## **OPERATION SAFETY NOTICE**

**206L-24-55**

**SUBJECT: Cyclic and collective flight controls rigging requirements.**

**Figure 1: Swashplate Support Visual Identification**

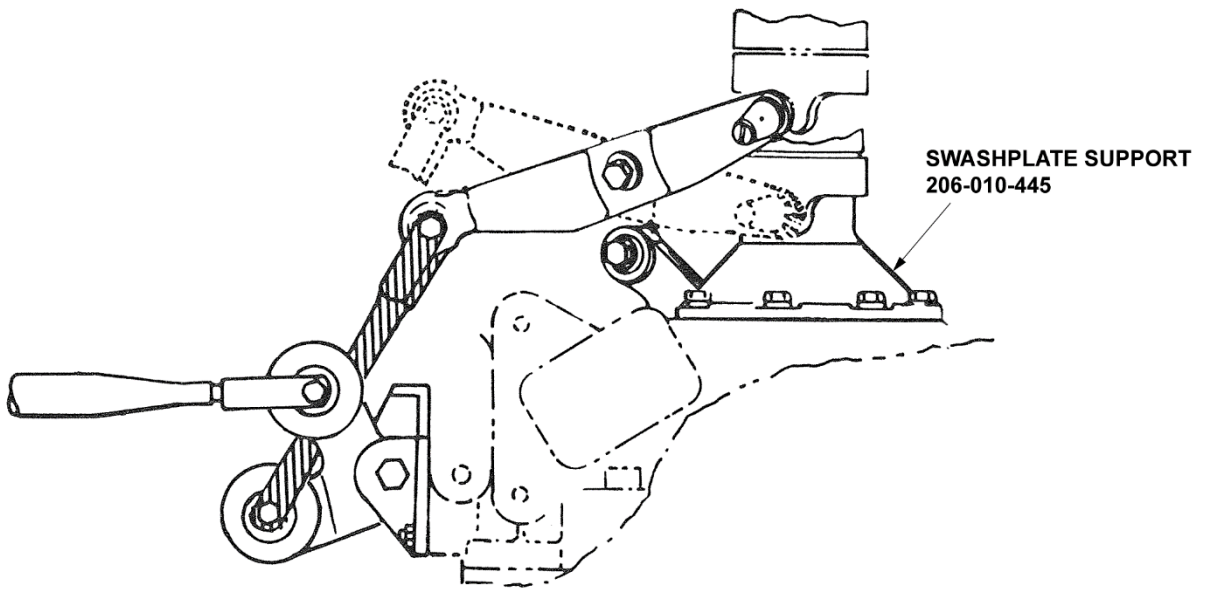
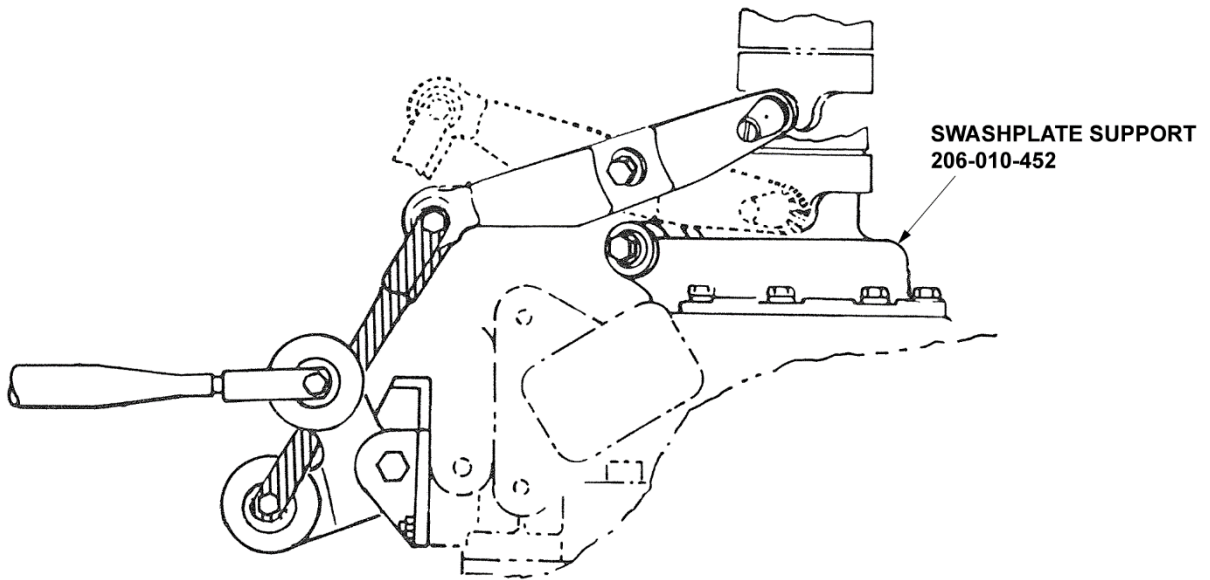
The latest 206-010-450 swashplate and support assemblies use the 206-010-445 support assembly which can be easily identified; see Figure 1.

This Operation Safety Notice (OSN) reminds owners and operators of 206L, 206L-1 and 203L-3 aircraft (prior to 206L-3 S/N 51308) that have the 206-010-445 support installed on their aircraft that they must rig the cyclic and collective flight controls to the dimensions shown in TB 206L-91-153 MOD B.
